Access Compliance Report

Public Rights-of-Way

Intersection ID: 10035680	Main Street: RED_RUST_LN	Cross Street: RAFFIA_RD	Location: NW
ADA ID: 4E71A4AC615E	Ramp Type: Directional1	Initial Pass/Fail: Fail	Overall Compliance: No
		Severity Score: 1.25

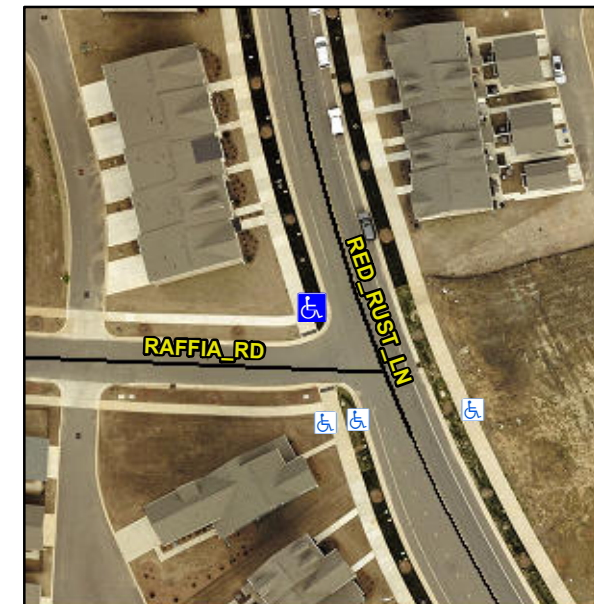
R304.5.3

Compliance	Description	Data	Compliance	Description	Data
N/A	Ramp Length (in)	90.0	N/A	Grade Break?	N/A
Yes	Ramp Width (in)	94.0	N/A	Grade Break Slope (%)	0.0
Yes	Ramp Slope (%)	5.7	N/A	Grade Break XSlope (%)	0.0
No	Ramp XSlope (%)	4.4			
N/A	Flare Type LT	N/A	N/A	Flare Type RT	N/A
N/A	Flare Slope LT (%)	N/A	N/A	Flare Slope RT (%)	0.0
N/A	Flare Traversable LT?	N/A	N/A	Flare Traversable RT?	N/A
N/A	Landing Length (in)	0.0	N/A	DWS Provided?	N/A
N/A	Landing Width (in)	0.0	N/A	DWS Contrast?	N/A
N/A	Landing Slope (%)	0.0	N/A	DWS Length (in)	N/A
N/A	Landing X Slope (%)	0.0	N/A	DWS Full Width?	N/A
N/A	Landing Curb? (Y/N)	N/A	N/A	DWS Offset LT (in)	N/A
N/A	Shared Landing?	N/A	N/A	DWS Offset RT (in)	N/A
N/A	Gutter Ponding?	0.0	N/A	Gutter Slope (%)	N/A
N/A	Gutter Lip Ht (in)	0.0	N/A	Gutter X Slope (%)	N/A
N/A	Painted X Walk1?	No		Road Slope (%)	1.7
	X Walk 1 Direction	To S		Road X Slope (%)	1.6
	X Walk 1 Width (in)	N/A		Clear Space?	N/A

Remove & Replace Entire Ramp.
